**re: Geotechnical Review of Grading Plan & Site Servicing  
Proposed Multi-Storey Building  
384 Arlington Avenue – Ottawa, Ontario**  
**to: Windmill Developments – Kristen Jorgensen –  
[Kristen.jorgensen@windmilldevelopments.com](mailto:Kristen.jorgensen@windmilldevelopments.com)**  
**date: October 7, 2024**  
**file: PG6263-MEMO.03**

Further to your request and authorization, Paterson Group (Paterson) prepared the current memorandum to document our review of the grading and servicing plans for the proposed multi-storey building to be located at the aforementioned site. This memorandum should be read in conjunction with Paterson Group Report PG6263-1 Revision 1 dated October 7, 2024.

# FIGURE 1 - SITE SERVICING PLAN REVIEW

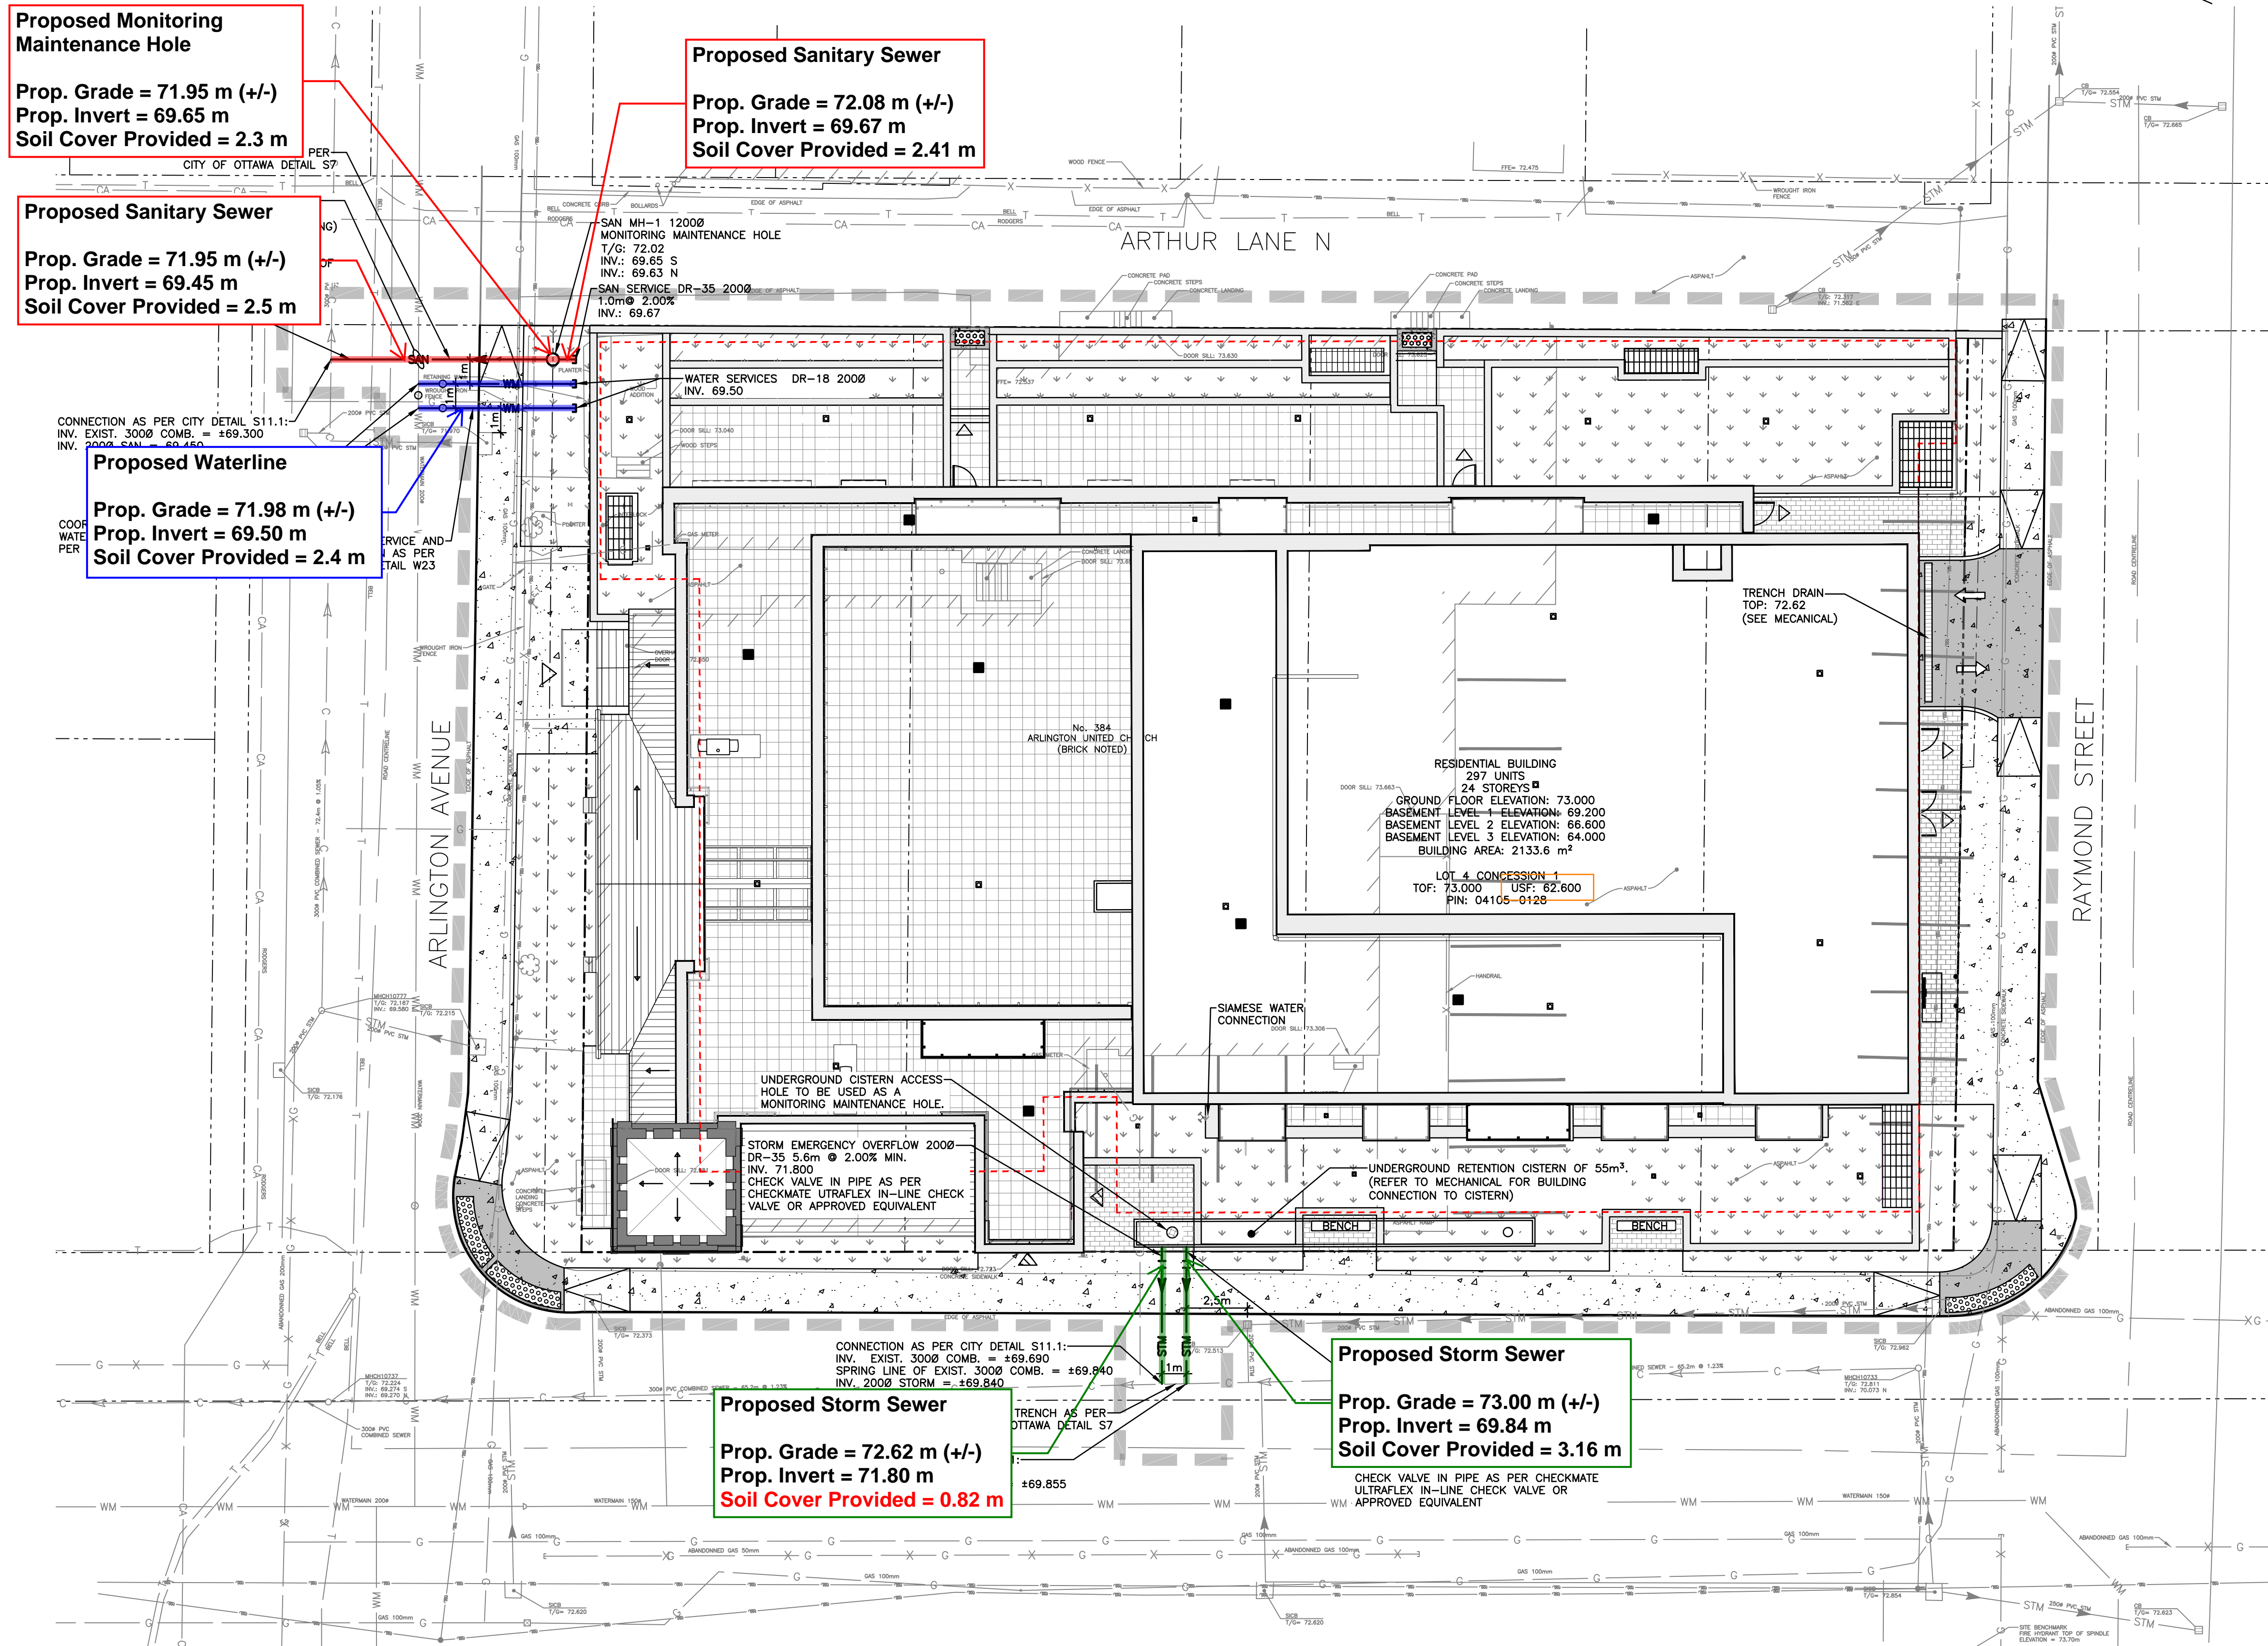
Based on our review of the site servicing plan, sufficient soil cover has been provided to the proposed watermain, sanitary services and the primary stormwater services. However, the emergency stormwater overflow services were noted to be provided with insufficient soil cover. Reference should be made to Figure 1 – Site Servicing Plan Review, attached.

Where insufficient soil cover (i.e. less than 2.1 m of soil cover is present above the obvert of the pipe) is available, the following frost protection criteria should be followed:

<b>Table 1 – Rigid Insulation Recommendations for Storm Sewer Pipes with Reduced Soil Cover</b>			
<b>Thermal Condition</b>	<b>Soil Cover Provided (mm)</b>	<b>Insulation Dimensions</b>	
		<b>Thickness (mm)</b>	<b>Extension (mm)</b>
Unheated	600 to 900	125	Extend 1200 mm horizontally beyond edge face of the pipe
	900 to 1200	100	Extend 1200 mm horizontally beyond edge face of the pipe
	1200 to 1500	75	Extend 900 mm horizontally beyond edge face of the pipe
	1500 to 1800	50	Extend 600 mm horizontally beyond edge face of the pipe
	1800 to <2100	25	Extend 300 mm horizontally beyond edge face of the pipe

All rigid insulation should consist of either Dow Chemical High-Load 40 (HI-40), Styro Rail SR.P400, or equivalent approved by Paterson. The placement of all insulation within the service trenches must be reviewed and approved by Paterson personnel at the time of construction
